Staff Summary Report

SUBJECT: Hold a public meeting for a Development Plan Review for BASELINE RETAIL located at 2005 West Baseline Road.

COMMENTS: Request for **BASELINE RETAIL (PL080308)** (Steven C. Cooper, owner; Chris Fergis, Fergis & Harding, Inc., applicant) consisting of a one story, 10,000 s.f. retail and restaurant building on 1.593 acres in the Commercial Shopping and Service District. The request includes the following:

DPR08178 – Development Plan Review including site plan, building elevations, and landscape plan.

NORTH ELEVATION
SCALE: 3/16" = 1'

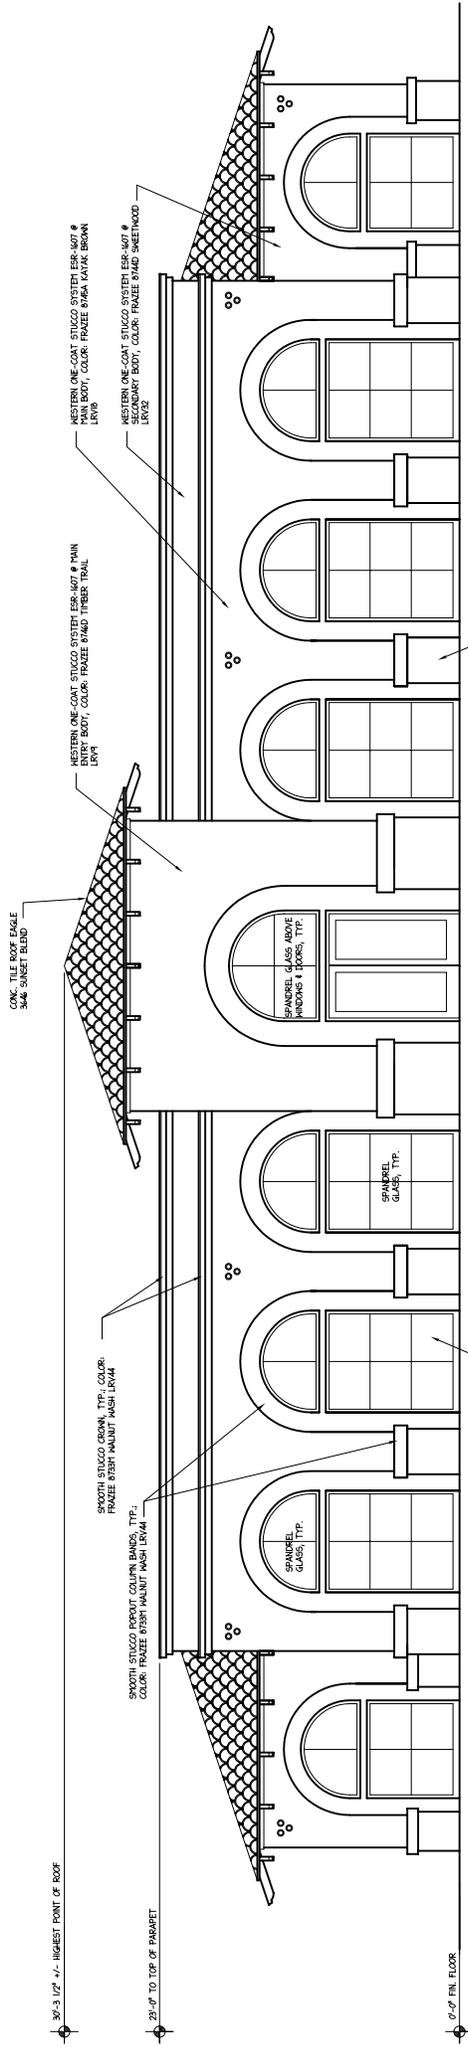
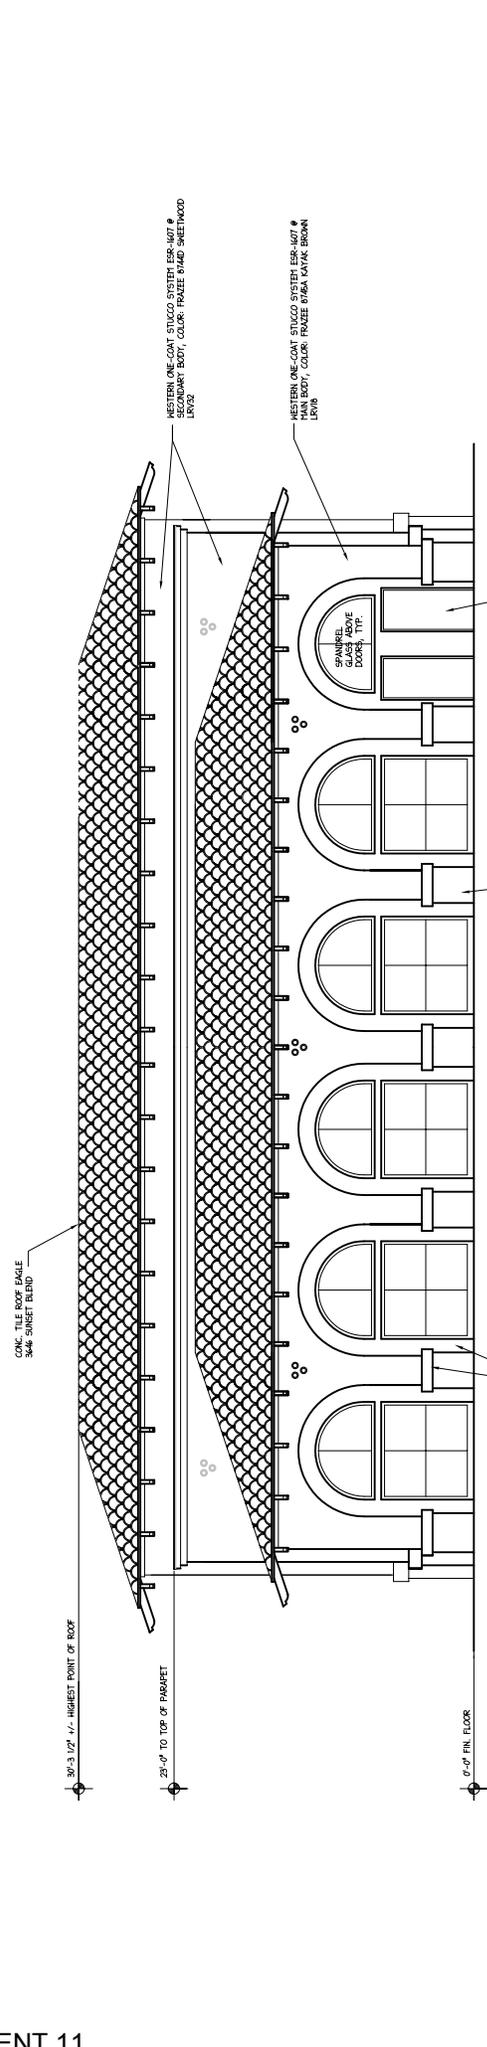
In response to criticism from the Commission of September 9 and October 28, the architecture of the proposed building has been modified from a formal, Roman motif to an expression that is Spanish Colonial in form. The symmetrical character of the architecture is maintained. A rectilinear, central one story block with flat roof and parapet is bisected north-south with a central, narrow tall hall. The tall hall is capped with a low slope hip roof. The north end of the tall hall, facing Baseline Road, contains the main building entrance. The south end of the tall hall contains a secondary entrance. Attached to the east and west sides of the one story block are two full length lower additions that are each capped with half hip roofs. With minor modifications, the east-west and north-south elevation pairs are almost mirror images of each other. Full length, round arched windows with raised jamb and arch "pop-outs" are placed regularly around the four elevations. The glazing is non-reflective, low-emissivity material.

The wall surfaces of the building are exterior plaster. The exposed portions of the roof are a barrel type, integral color brown concrete roof tile. The exterior plaster field surfaces are three colors: a dark brown field for the building base all around and for the full height of the tall hall, a medium brown field for the upper part of the central one story structure, and a medium tan for the upper part of the

east and west additions and for the plain frieze board of the one story. Additionally, there is a light tan accent for the raised pop-outs that articulate the arched windows and horizontal belts that are above and below the frieze board at the top of the central one story structure.

8. Provide main colors and materials with a light reflectance value of 75 percent or less. The Frazee 8746N "Timber Trail", 8745A "Kayak Brown", 8744D "Sweet-wood" and 8733M Walnut finish for the exterior plaster field colors and accent and the Frazee 8805D "Stonington" for the exterior hollow core metal doors are approved. The 3646 "Eagle" Sunset Blend barrel concrete roof tile is approved. Submit any additions or modifications for review during building plan check. During construction, planning inspection staff field verifies colors and materials.

9. Doors and Windows:
 - a. Use low-e glass in the window wall system, as indicated.
 - b. Identify the reflectivity in the glazing and verify the glazing system has some transparency from exterior to interior. This feature will enhance activity support as outlined in the Police Report, dated September 22, 2006.

- c. Provide bronze anodized aluminum frames to relate to the coloring of the exterior plaster.
10. Provide secure roof access from the interior of the building. Do not expose any part of roof access to public view.

14. Illuminate entrances continuously from dusk to dawn.
15. Incorporate exterior lighting into underside of segmental arches in the four building elevations.

LANDSCAPE PLAN
 SCALE: 1" = 20'

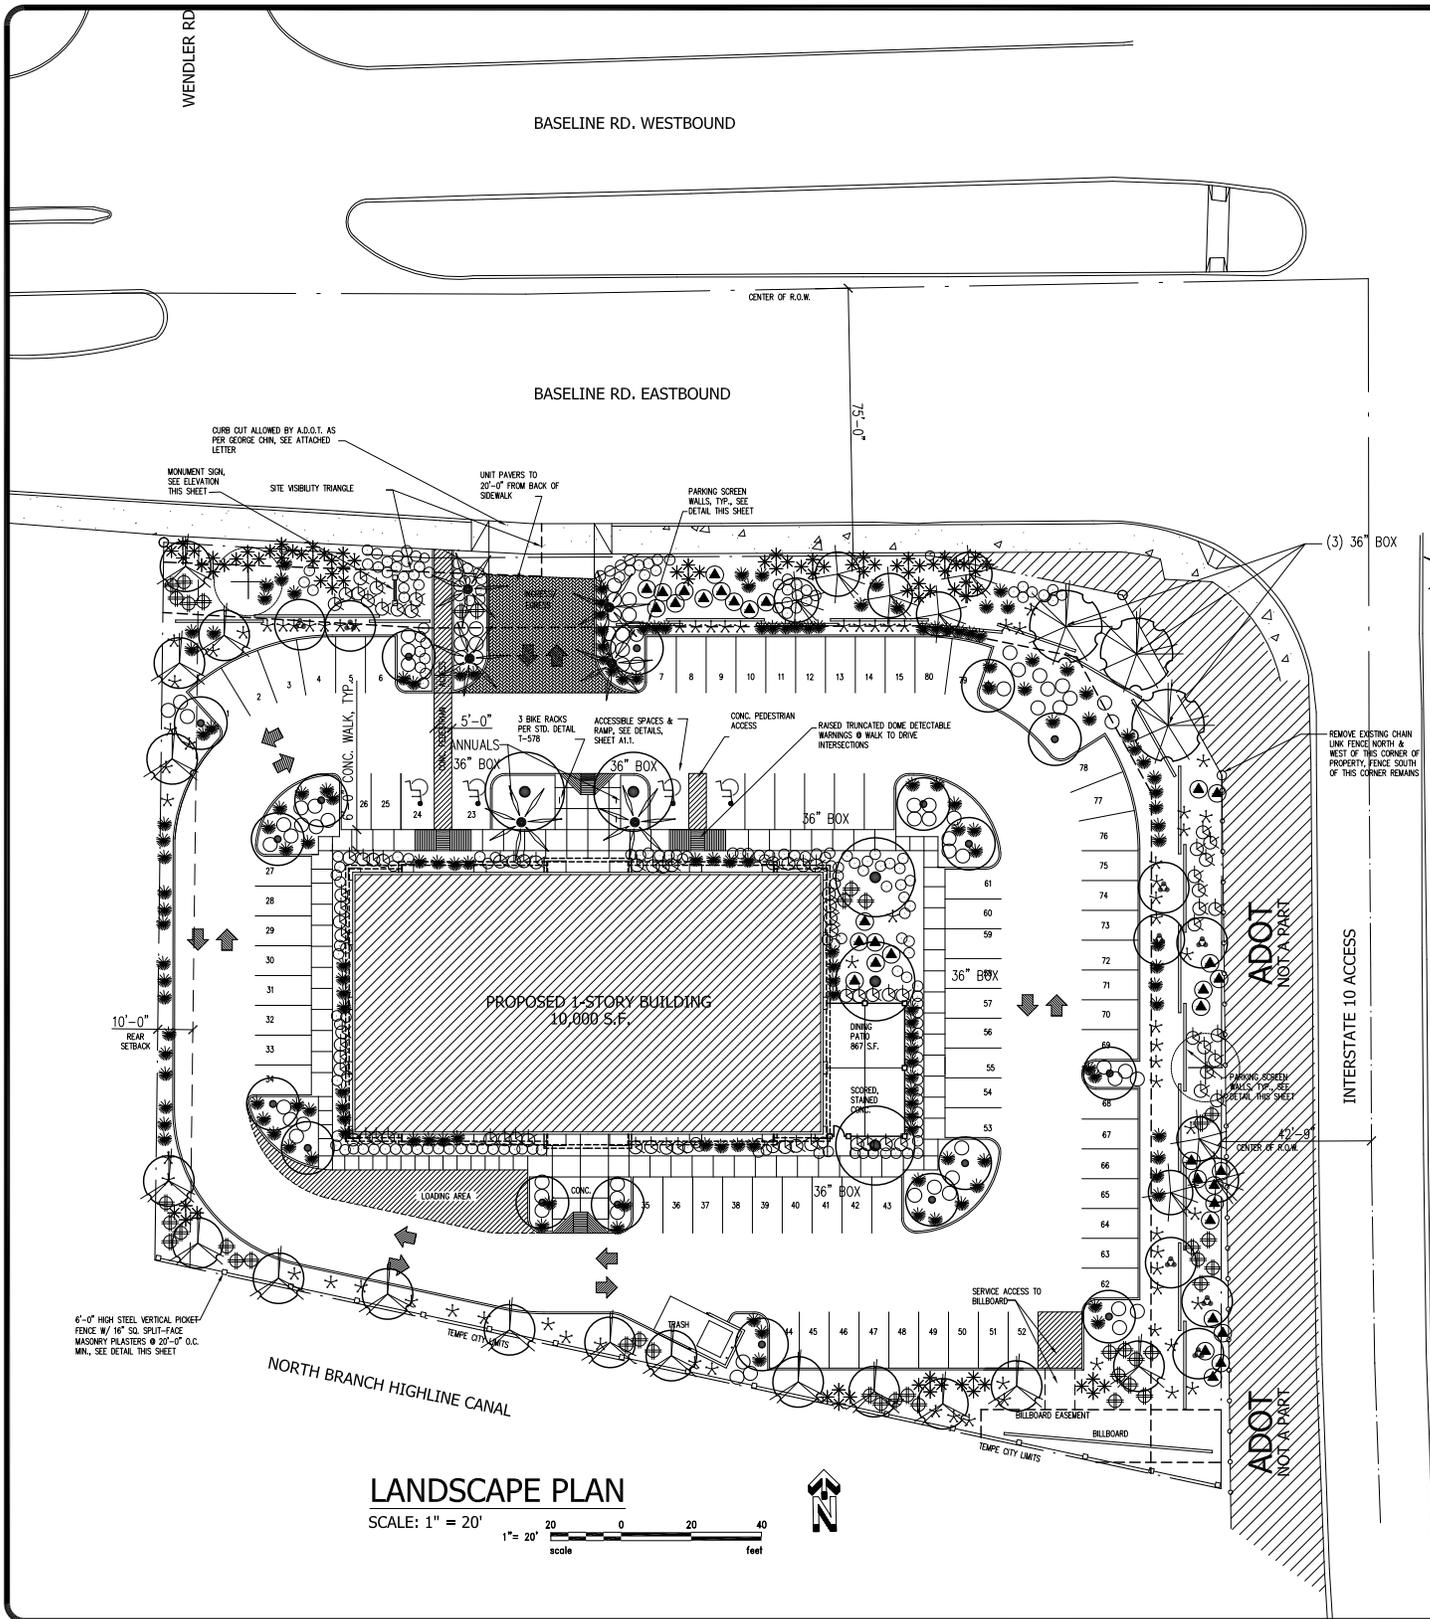
The site edges feature several existing native and arid-adapted trees in the Baseline frontage and (off-site) along the western edge adjacent to the existing open irrigation ditch (photo 3). The trees to the west of the site will be left undisturbed. Two major existing Palo Verdes on site, one on the Baseline frontage directly south of Wendler Drive (photo 2) and one on the east adjacent to the A.D.O.T. on-ramp frontage and north of the bill board (photo 7), will be retained. The A.D.O.T. on-ramp frontage itself has been landscaped with arid-adapted trees and plant material which will not be disturbed. The site landscape concept proposed is typical of a suburban site. The landscape plant legend is arid adapted and features Mesquite, Desert Museum Palo Verde and Sweet Desert Acacia. A pair of Washington Fan Palms will flank the main building entrance at the north elevation. As a counterpoint, a row of Evergreen Elm, appropriately proposed along the buried waterway on the west and along open canal on the south, will provide a shade and visual buffer at the west and south site edges.

16. Provide minimum 24" box installation for each landscape island canopy tree.
17. Complete the Evergreen Elm tree row on the west edge of the site. Fill in the planting area adjacent to the drive and west of the building with Elms at approximately 30'-0" on center. Coordinate with civil plan the location of the buried irrigation line so the Elm and the buried pipe installations do not conflict.

19. Include requirement in site landscape work to protect and maintain existing on-site trees to remain during construction period and generally de-compact soil in all planting areas on site and in public right of way and remove construction debris from planting areas prior to landscape installation.
